Please accept all the information I am submitting in regard to the Final Environmental Assessment for C&H Hog Farms, Newton County, Arkansas dated December 2015.

**Comments on the "Final Environmental Assessment For  
C&H Hog Farms Newton, Co. Arkansas"**

**Final Environmental Assessment  
C&H Hog Farms  
Newton County, Arkansas**

##### **USGS Gaging Stations (3 - Monitoring Stations – Surface/Groundwater)**

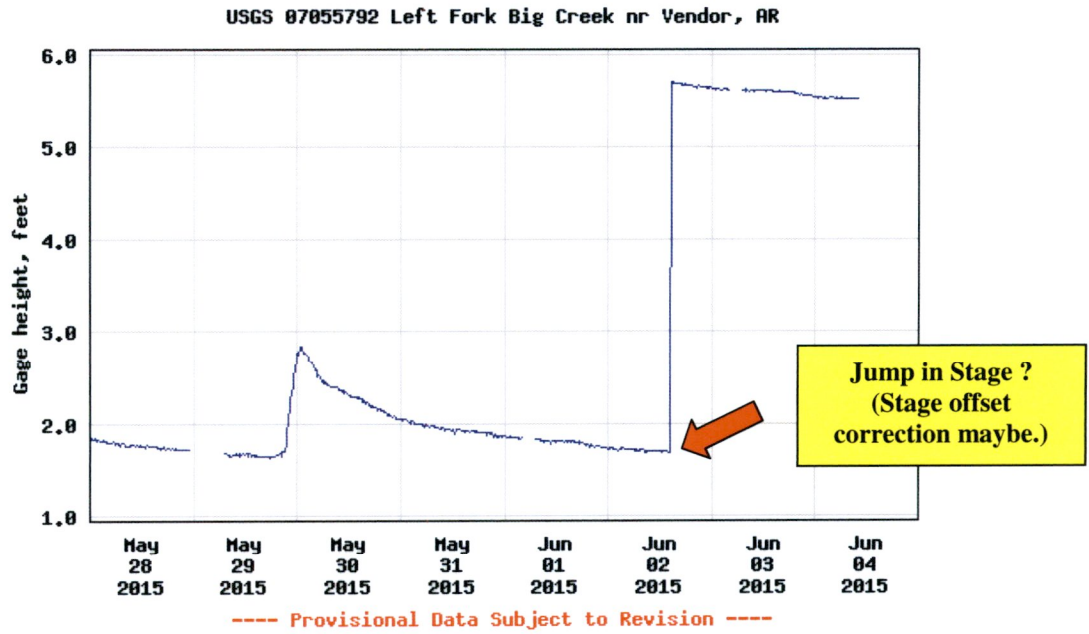
The next section concerns the three USGS stations that monitor the two major forks and outlet of the Big Creek Tributary. Of the eight monitoring stations, these three stations could add information concerning surface water as well as the combination of surface and groundwater that run in the channels of Big Creek. These stations measure the fraction of water in the tributary, the fraction that passed over the surface at the point of these stations and being able to monitor them over time and have access from remote online by all is good. One can see the water at these stations, and watch it online. But this again is only a fraction of the water budget for the Big Creek Tributary, there is a lot more water that you can't see from these stations or that is being monitored for quality and volume. This makes it even more important to insure the quality of the data the stations do monitor is meaningful.

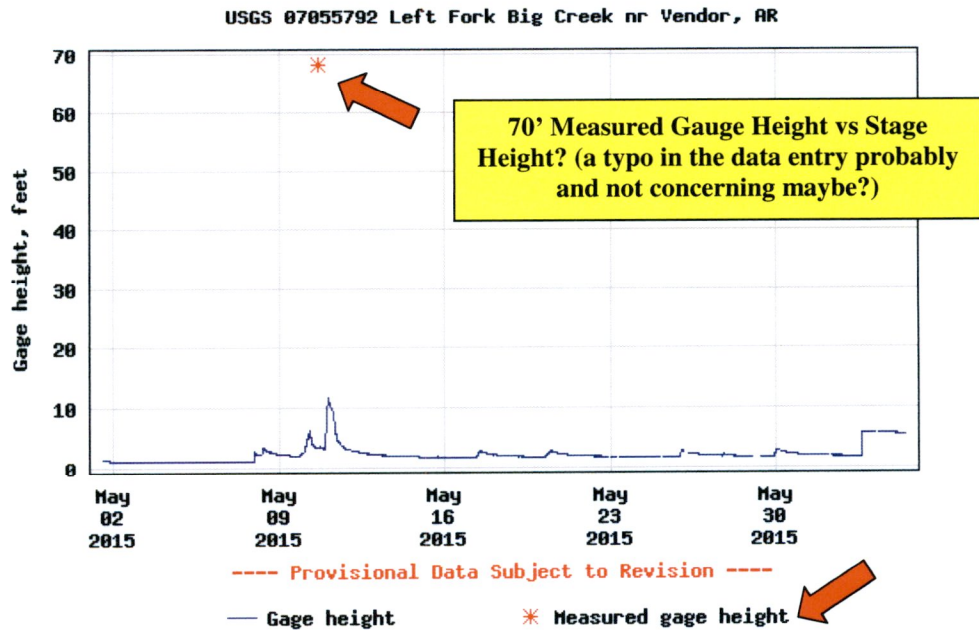
USGS 07055792 Left Fork Big Creek Near Vendor, AR had a few startup issues, but that could be expected. The station reported May 2015-June 2015. Where is that online “preliminary” data that as of today it is not available online? The image below are screen dumps from from when the station was operational and had data available.

**Figure 3.1. USGS 07055790 Big Creek near Mt. Judea, AR**

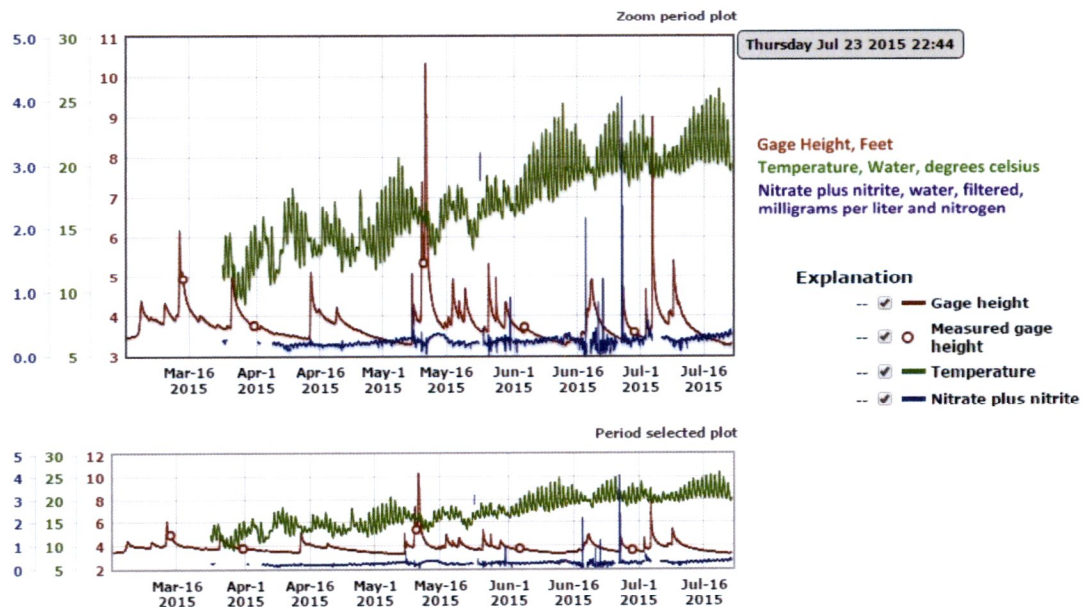
This station has provided useful information and would provide a very important point to keep an eye on parameters like “**Nitrate plus Nitrite**”, gauge height and precipitation for that fork of the Big Creek Tributary. It is in close proximity of the CAFO. Unfortunately there have been several issues that have been reported to the USGS office in Little Rock, AR about accuracy of some of the parameters and asking for information about calibration data for the sensors. It is clear to see that the field data available for establishing a rating curve to determine discharge is in progress, but the other parameters appear to be without calibration data. So there might be a lack of confidence by some questioning how meaningful this water quality aspect of this data truly is. These stations could provide precursors to threats to the surface and groundwater. Many feel that these stations are standing guard and there is nothing to worry about.

A recent attempt online to access USGS 07055790 Big Creek at Mt. Judea, AR gaging station, where are the water quality parameters like Nitrate plus Nitrite that the FONSI speaks of should be available? They have been available in the past. Some of the earlier “preliminary” data is not there as well.

# USGS 07055790 Big Creek at Mt. Judea, AR gaging station.

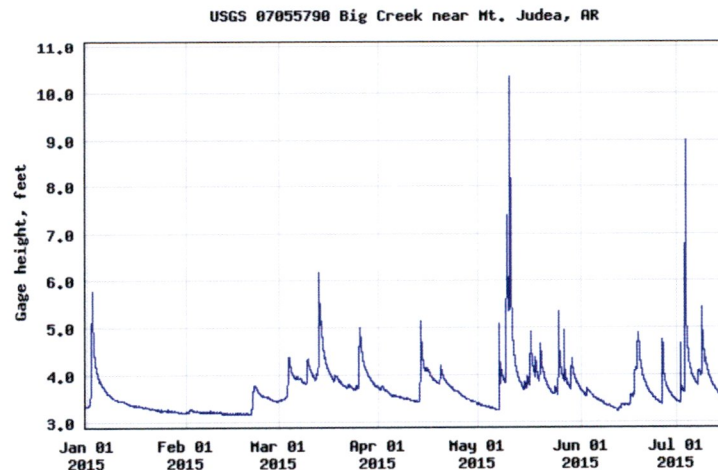
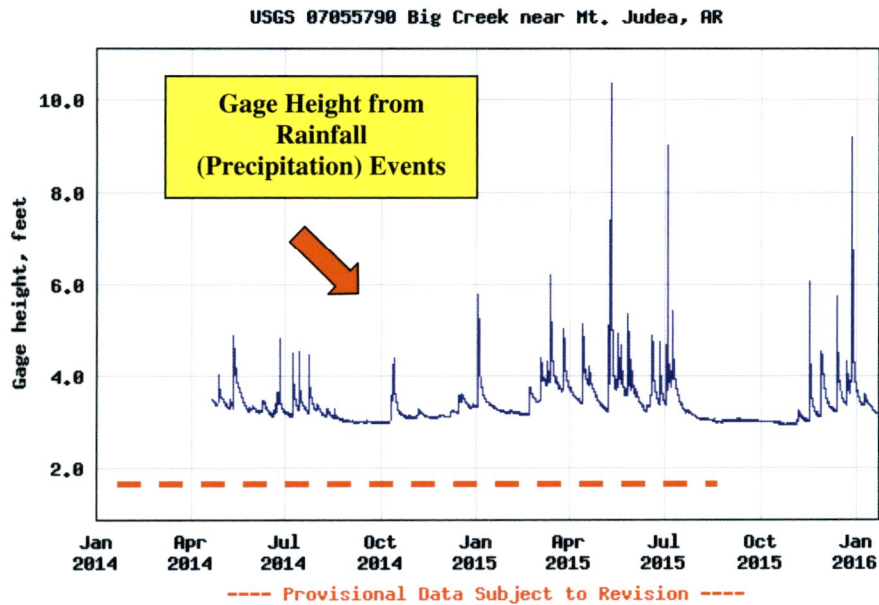
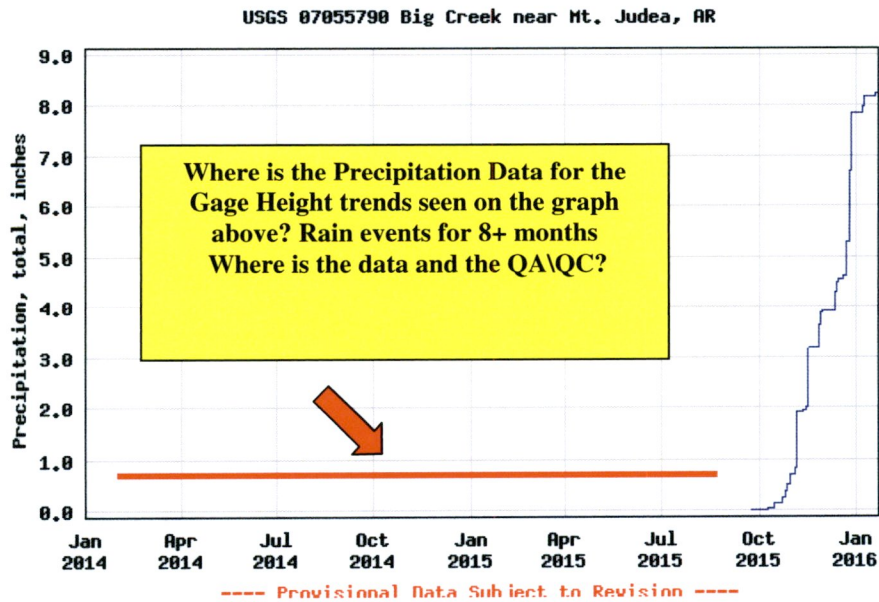
Where are the other “real-time” parameters like Nitrate plus Nitrite ?

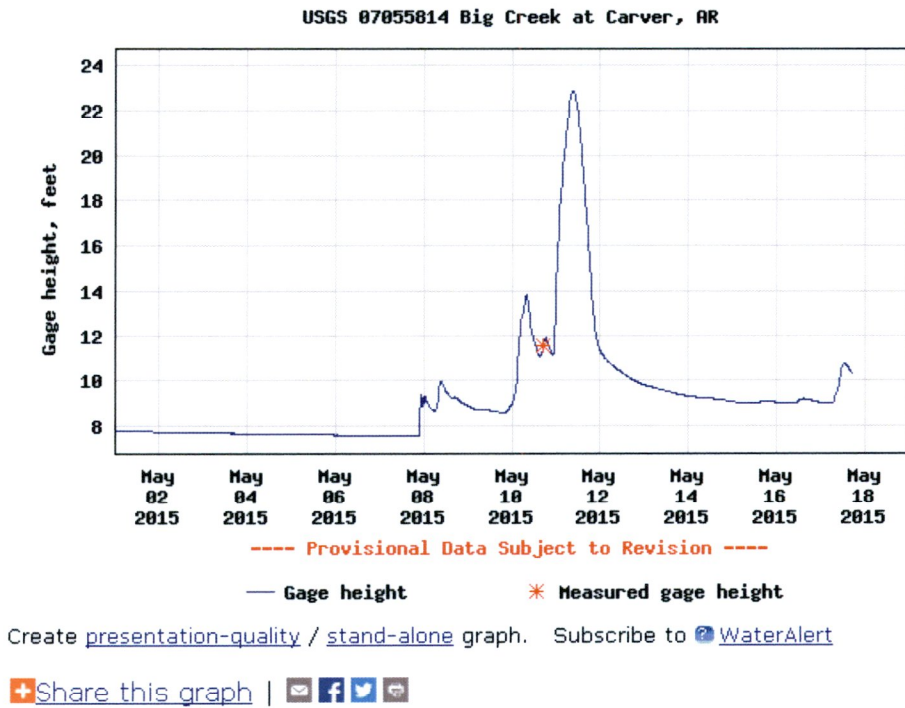
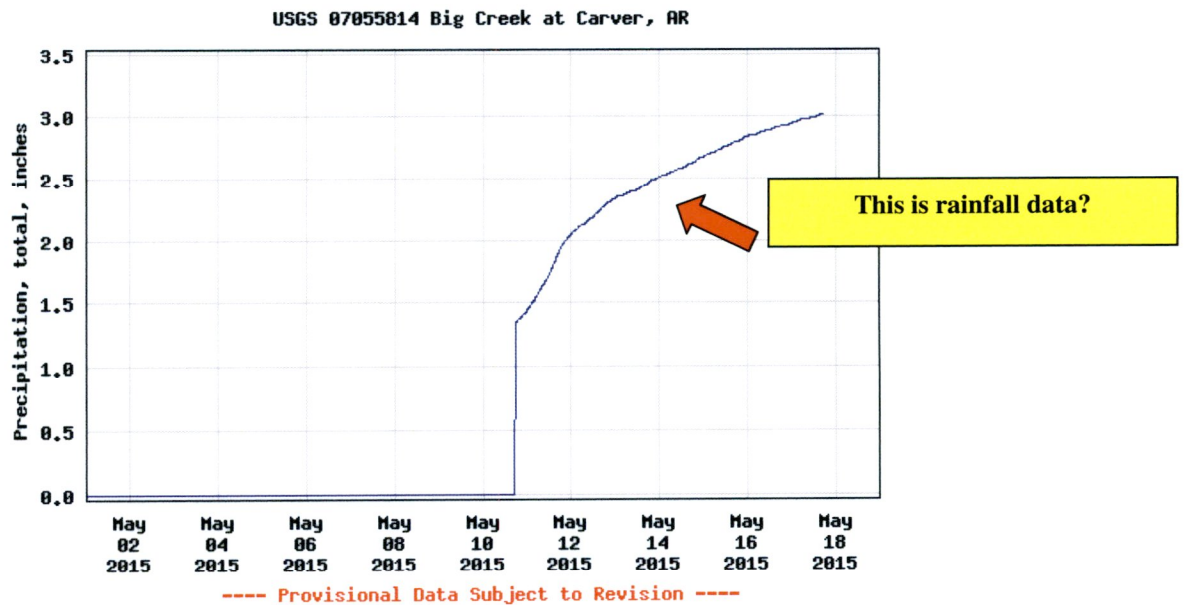
This is from USGS 07055814 Big Creek at Carver, AR monitoring station. This station was instrumented with Nitrate plus Nitrite, turbidity, DO sensors etc. I know there have been some high water issues as you can see, but the precipitation gauge was flat a long time and then he slow drip curve for many days?
